**Submission on proposed mixed use and in-fill affordable housing development (SSD-67424709)  
9-13 Blaxland Road and 424 Concord Road, Rhodes**

## Attachment A – Independent Review of Wind Report

RE: ADJACENT DEVELOPMENT AT 9-13 BLAXLAND RD RHODES  
- REVIEW OF WIND ENVIRONMENT REPORT

Figure 1: Results from the RWDI study.

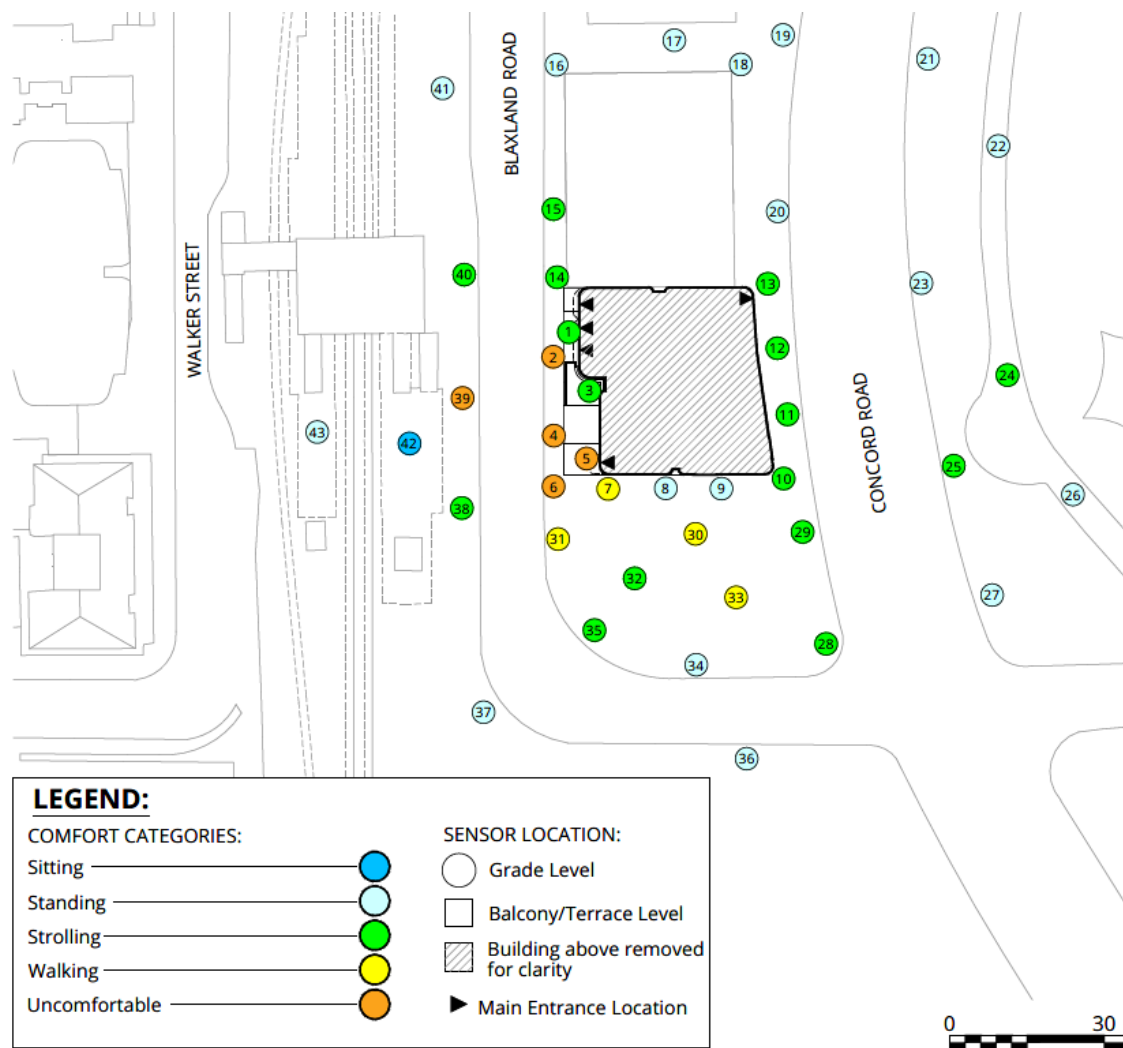
The report shows that even the most lenient "walking" criterion is exceeded across a large section of Blaxland Road (refer to the orange areas in Figure 1, below). Further the wind conditions at Point 5 exceed the safety limit. These areas all currently experience favourable wind conditions and meet the standing criterion, which is expected particularly at the entrance to the train station and adjacent bus stop. These currently favourable wind conditions will no longer be tolerable even for the activities described as objective walking, running without lingering.

The mitigation proposed in the RWDI report: "A series of solid planters, each 1 meter in height ... at the southwest corner of the site... supplemented with dense foliage" will not go nearly enough to mitigate this large scale impact, including a significant impact on the wind conditions across the road at the bus stop and train station entrance.
